CHANGE IN THE WHEEL NUT (M22X1.5) TIGHTENING TORQUE

Picture 1. Wheel nut tightening sequence.

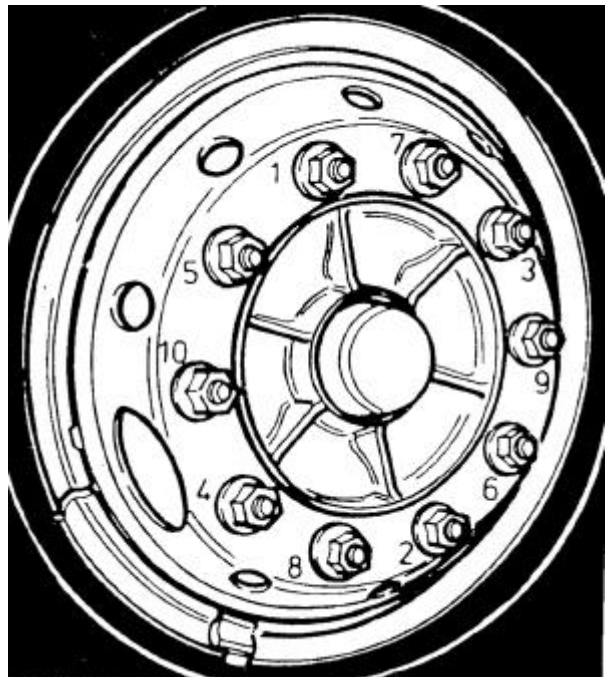
The tightening torque of the wheel nut with M22x1.5 thread has been changed.

According to the new tightening instructions the installing of the wheel nuts have to be done with the threads oiled.

- Inspect that all the nuts and bolts are clean and undamaged.
- Oil the threads and the sliding surface between the nut and its washer lightly.
- Tighten the wheel nuts to 550...650 Nm torque.
- The tightening sequence is shown in picture No. 1.
- Inspect the correct tightening torque at the latest after one day's driving.
